DESCRIPTIVE REPORT

Registry No. FE-256WD

General Locality Boston Harbor--Salem Harbor

ADDENDUM TO ACCOMPANY SURVEY FE-256WD

FE-256WD
MASSACHUSETTS
BOSTON HARBOR & SALEM SOUND
PRESIDENT ROADS & SALEM CHANNEL
8 AUG TO 13 NOV, 1981
SCALE = 1:5,000
N A 1927 DATUM
SOUNDING IN FEET AT MLLW
RESULTS OF THE INVESTIGATION OF ITEM 1
SHEET 1 OF 4

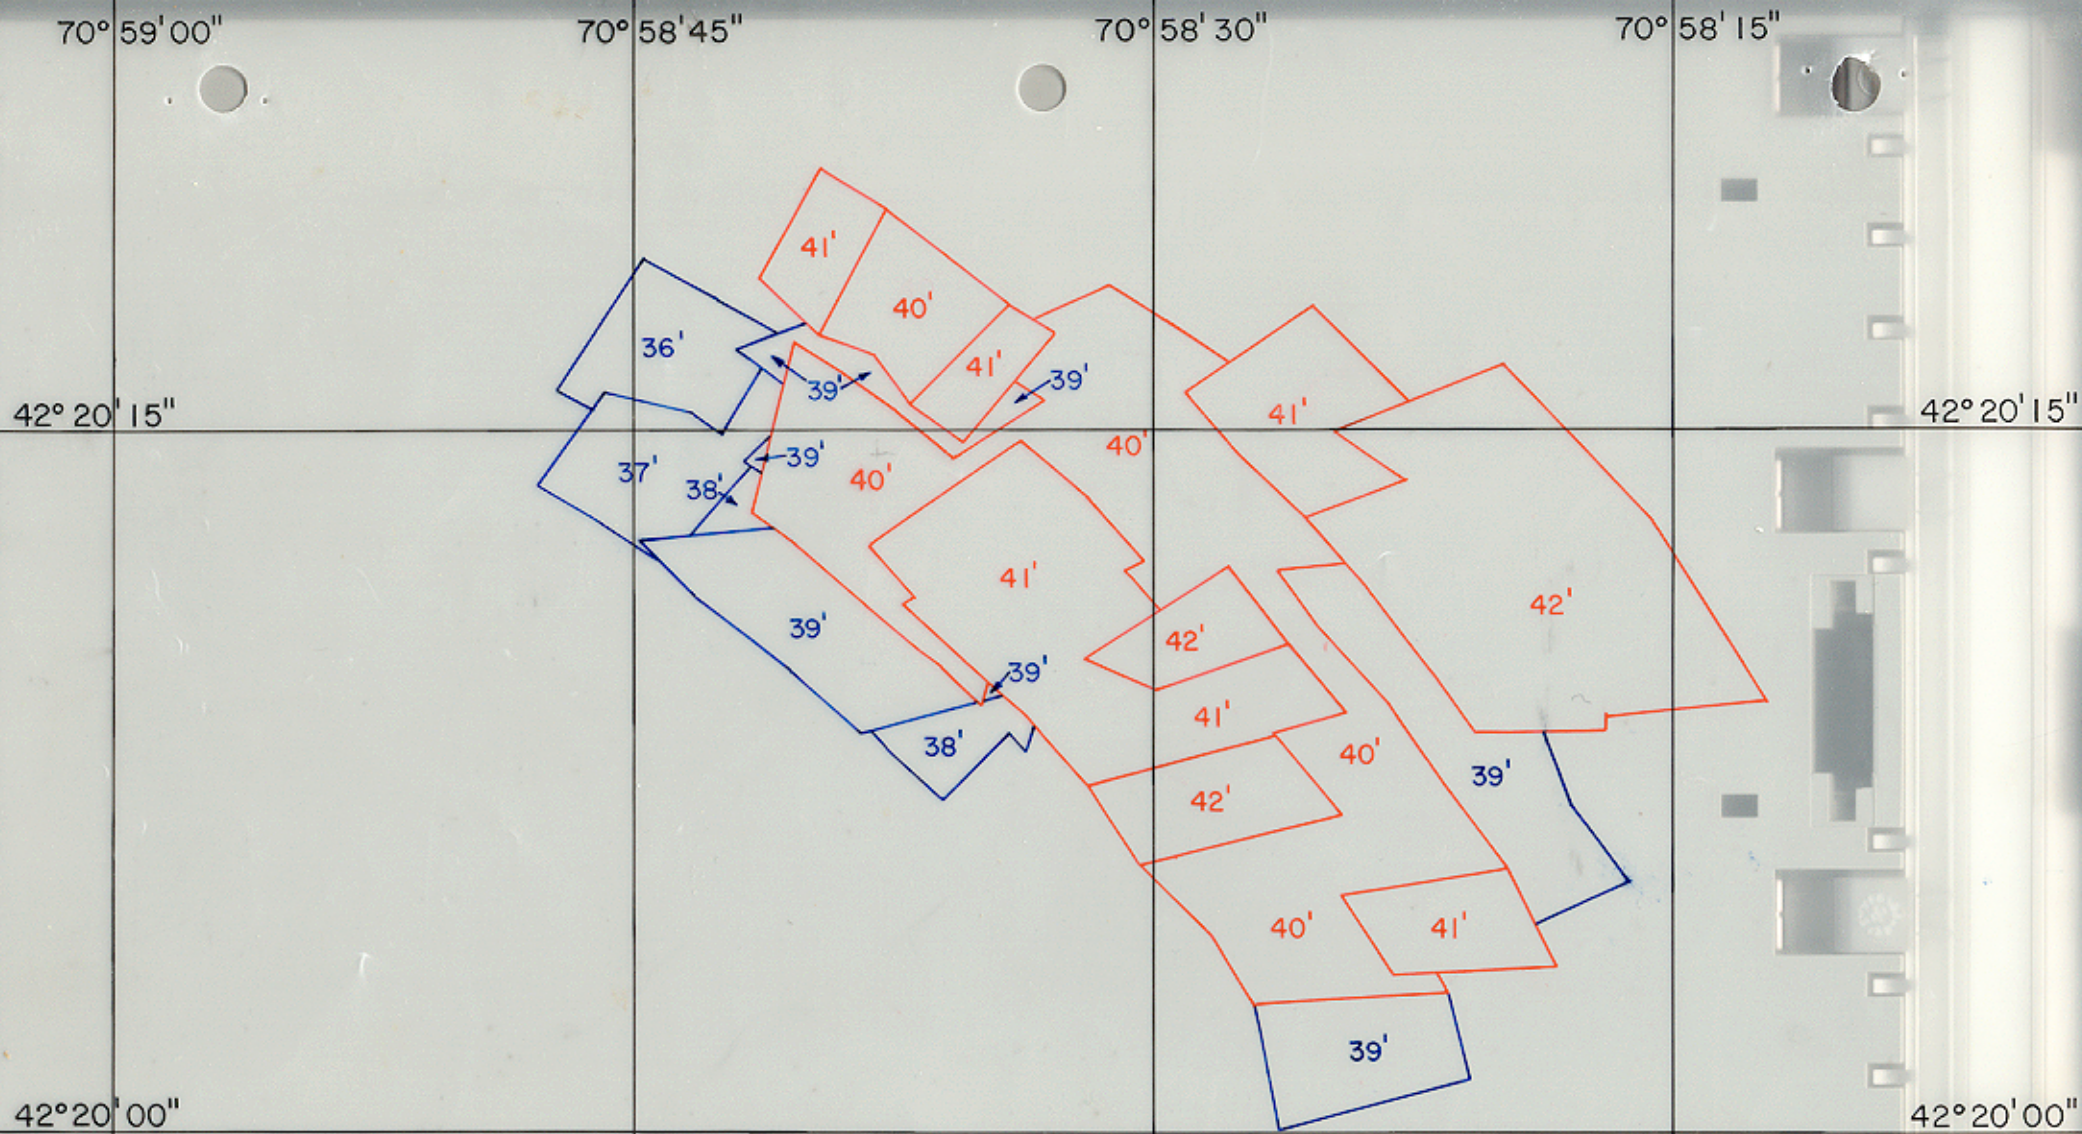
- A. Item 1: Work was begun on 3 November 1981 and completed on 11 November 1981. The item was investigated using side scan sonar, a fathometer search and finally diving to obtain a least depth. Side scan sonar revealed a prominent rock outcrop protruding several feet above a relatively flat sandy bottom in the area charted "32-foot Rk." Divers obtained a least depth at that position of 3~~2~~⁴ feet. ✓

It is recommended that the item be considered verified on the chart pending final processing of the item investigation records. *See the Addendum* ✓

a. Item #1, a charted 32-foot sounding on a rock in Latitude $42^{\circ}32'32.5''N$, Longitude $70^{\circ}48'25.0''W$, originated with a report submitted by the NOAA Ship FERREL (Chart Letter 1467 of 1972). This item was found by the present survey in Latitude $42^{\circ}32'31.51''N$, Longitude $70^{\circ}48'21.36''W$ and is identified as a rock outcrop. A least depth of 34 feet (at MLLW) was obtained on this feature. The method of positioning this feature on the present survey is by visual fixes with check angles. The visual control stations used are third order or better geodetic control stations and have been office verified. Also these visual stations are charted as either fixed aids to navigation or landmarks. It is recommended that this submerged rock be charted with the revised present survey least depth of 34 feet. See sheet 1 of 4.

FE-256WD
 MASSACHUSETTS
 BOSTON HARBOR & SALEM SOUND
 PRESIDENT ROADS & SALEM CHANNEL
 8 AUG TO 13 NOV, 1981
 SCALE = 1:5,000
 N A 1927 DATUM
 EFFECTIVE DEPTHS IN FEET AT MLLW
 RESULTS OF THE INVESTIGATION OF ITEMS 2 & 3
 SHEET 2 OF 4

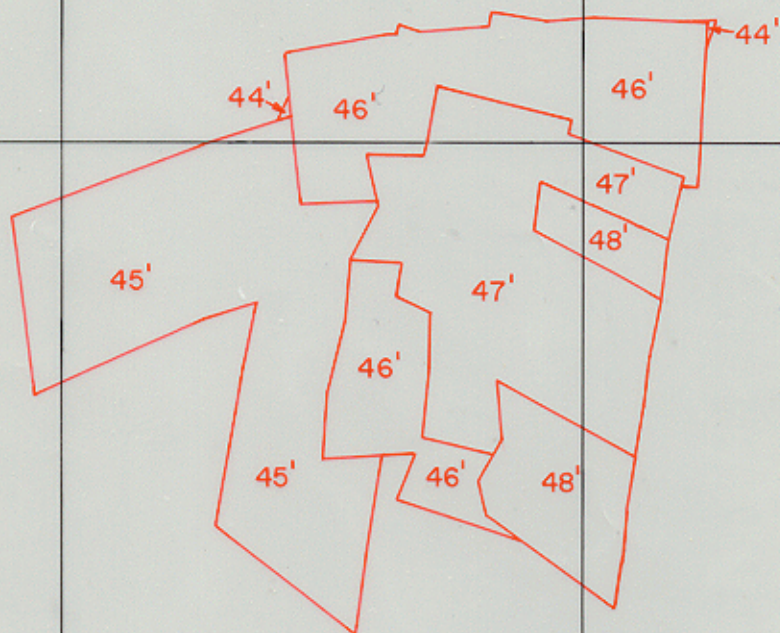
- A. Item 2: Work was begun on September 14, 1981 and completed on October 22, 1981. The item was investigated using side scan sonar, hydrography and launch wire drag, all of which failed to detect an obstruction. ~~The entire 100-meter radius circle around the item was cleared to a depth of 40 feet except in the NW corner where a 39-foot depth was encountered. This 39-foot depth agrees with the charted depth in that area.~~ *Most of the 100 meter* ³⁶ *foot clearance* ✓

The item is considered disproved and should be deleted from the chart. *See the Addendum.* ✓

- A. Item 3: Work was begun on 25 September 1981 and completed on 2 November 1981. The item was investigated using side scan sonar, hydrography and launch wire drag. The entire 150³⁴-meter radius circle around the item was cleared to a minimum depth of ~~40~~ feet. No obstructions were encountered. ✓

It is recommended that the item be considered disproved. ~~The "35-Obstr" should be removed from the chart and replaced with a 40-foot sounding. do not concur - See the Addendum.~~ ✓

b. Items #2 and #3, hangs at an effective depth of 36 feet and 38 feet, respectively, with a clearance effective depth of 35 feet for both in Latitude $42^{\circ}20'14.0''N$, Longitude $70^{\circ}58'38.5''W$ and Latitude $42^{\circ}20'10.2''N$, Longitude $70^{\circ}58'26.0''W$, respectively, originate with FE-177WD (1960). These items were charted as a dangerous submerged obstructions but have been removed from the chart, presumably from advance information from the present survey. The required search areas of these items have been cleared by wire drag by a minimum effective depth of 36 feet for Item #2 and 39 feet for Item #3. Clearance depths within the assigned search areas range from 36 to 42 feet which are from 0 to 8 feet above the charted bottom. No hangs or groundings occurred during the investigations of these items. The wire drag within itself is not sufficient for disproval, but, the present wire drag coupled with the reconnaissance side scan sonar search and the fact that this area is an anchorage area that is maintained (surveyed and dredged as necessary) gives sufficient reason to consider disproval. These items are not presently charted and are not recommended to be charted. No additional field work is recommended on these items. See sheet 2 of 4.
